Reply to anonymous referee #1 [Note reply to referee #2 follows this reply.]

**This paper describes the history and technical aspects of an in-situ analyser that has been running in Lauder, NZ since January 2007. The spectrometer measures a variety of trace gas species, but this paper focuses on methane, carbon monoxide, and nitrous oxide. This paper describes a high quality, unique dataset that promises to be very valuable to the scientific community.**

#### Reply to anonymous referee #2

Fig15. (A) new:

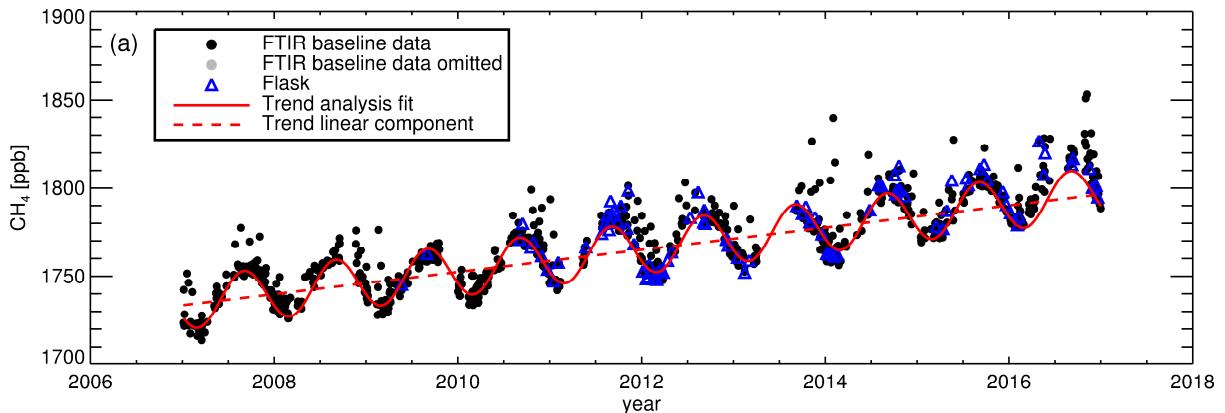
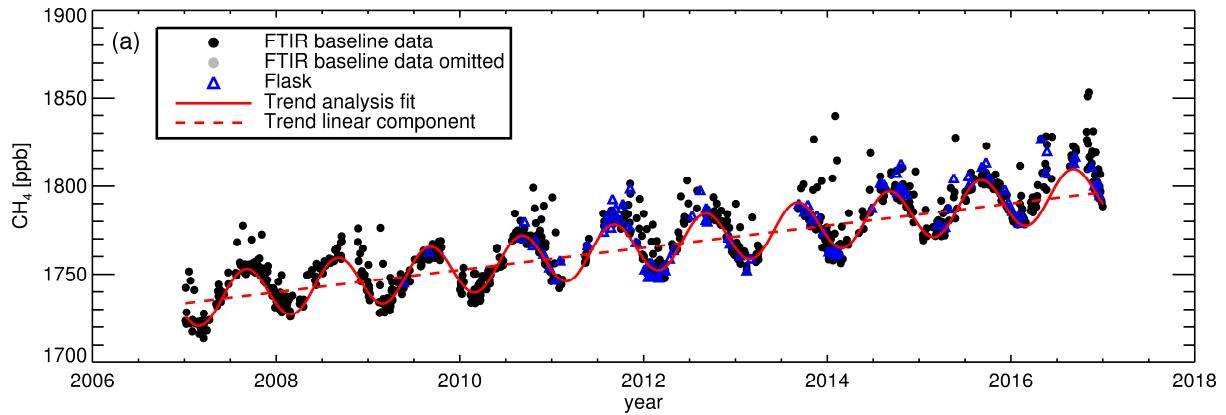
[Fig 17: I had trouble seeing the blue triangles. Could you make them bigger?](#)

Sure. The blue triangle (flask data) symbol size is increased by 33% in Figs. 15 a, b, c (any larger they could be disproportionate). The new figures are incorporated into the revised manuscript.

As an example, the new Fig 15a is displayed directly below, and the old fig15a beneath it (for comparison).

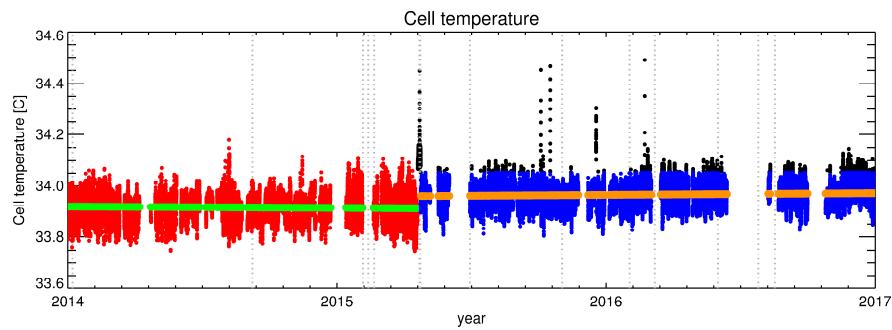
**P8L19: A thermocouple will show significant more short term and long term drift than any PT100 so the reason for this change is questionable. There also very thin, fast response time, PT100 RTDs.**

The original reason for the replacement was to use a temperature probe with a faster response to allow investigation of temperature disequilibrium effects and to bring the Lauder FTIR prototype componentry more in line with the Spectronus FTIR system (which uses the Type-J thermocouple). The biggest ‘step’ in temperature monitoring was the replacement of the external LM335 with faster response in vitro probes.

In hindsight, we agree, a change from the PT100 to the thermocouple was not needed as both sensors gave similar readings during temperature disequilibrium testing, and in standard operating conditions both sensors give similar readings (see fig 3., before and after April 2013). This is stated as such in Section 5.2.1: “Even though the thermocouple has a faster response time, no significant changes in temperature precision were seen.”

Any sensor drift is undesirable. Small long-term temperature drift will not affect the calibrated timeseries, as the calibration method will effectively cancel any drift (assuming the drift effects calibration and sample measurements in the same manner). Given the dataset used in this research we cannot explicitly diagnose any long-term (or short term) temperature drift. The 10-minute averaged cell temperature from 2014.0 to 2017.0 is displayed in the figure below. The dataset is split into two at  $\sim$ 2015.3. This is when there was a substantial change in the laboratory air conditioning which effected the FTIR enclosure temperature, hence cell temperature. The red and blue subsets are cell temperatures with 6-sigma outliers removed pre and post laboratory temperature change. The green and orange lines are linear fits to the red and blue subsets respectively. The linear temperature trend prior to 2015.3 was  $\sim$ 0.006  $^{\circ}\text{C}$  year $^{-1}$  and 0.007  $^{\circ}\text{C}$  year $^{-1}$  post 2015.3. The trend cannot be completely attributed to sensor drift, as cell temperature maybe slowly varying, but the current analysis is a good indicator of upper limits on temperature sensor drift, and if so due to the small magnitude then such drift will be easily compensated for in the calibration method.
